Access Compliance Report

Public Rights-of-Way

Intersection ID: 21869	Main Street: SHARON_RD	Cross Street: SHARON_HILLS_RD	Location: SE
ADA ID: CBF3A492F4B5	Ramp Type: PerpDiag	Initial Pass/Fail: Fail	Overall Compliance: No
Severity Score: 13.75			
Codes/Mitigation Info/Possible Solution		Field Measurements/Component Compliance

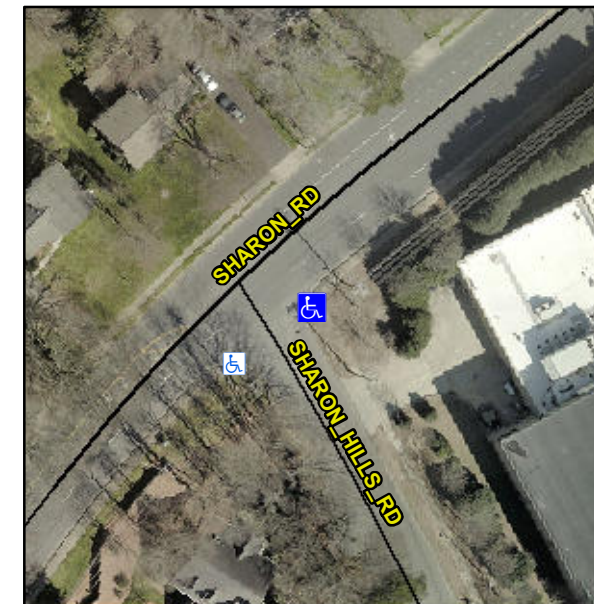
R304.2.2, R304.5.3

Compliance	Description	Data	Compliance	Description	Data
N/A	Ramp Length (in)	106.0	No	Ramp Slope (%)	9.2
Yes	Ramp Width (in)	48.0	No	Ramp XSlope (%)	2.8
N/A	Flare Type LT	N/A	N/A	Flare Type RT	N/A
N/A	Flare Slope LT (%)	N/A	N/A	Flare Slope RT (%)	N/A
N/A	Flare Traversable LT?	N/A	N/A	Flare Traversable RT?	N/A
N/A	Landing Length (in)	N/A	N/A	DWS Provided?	N/A
N/A	Landing Width (in)	N/A	N/A	DWS Contrast?	N/A
N/A	Landing Slope (%)	N/A	N/A	DWS Length (in)	N/A
N/A	Landing X Slope (%)	N/A	N/A	DWS Full Width?	N/A
N/A	Landing Curb? (Y/N)	N/A	N/A	DWS Offset (in)	N/A
N/A	Shared Landing?	N/A			
N/A	Gutter Ponding?	N/A	N/A	Gutter Slope (%)	N/A
N/A	Gutter Lip Ht (in)	N/A	N/A	Gutter X Slope (%)	N/A
N/A	Painted X Walk1?	No	N/A	Painted X Walk2?	No
	X Walk 1 Direction	To N		X Walk 2 Direction	To SW
N/A	X Walk 1 Width (in)	N/A	N/A	X Walk 2 Width (in)	N/A
	X Walk 1 Slope (%)	0.3		X Walk 2 Slope (%)	2.9
	X Walk 1 X Slope (%)	0.4		X Walk 2 X Slope (%)	2.5

Remove & Replace Curb Ramp With Two New Directional Ramps or Equivalent.
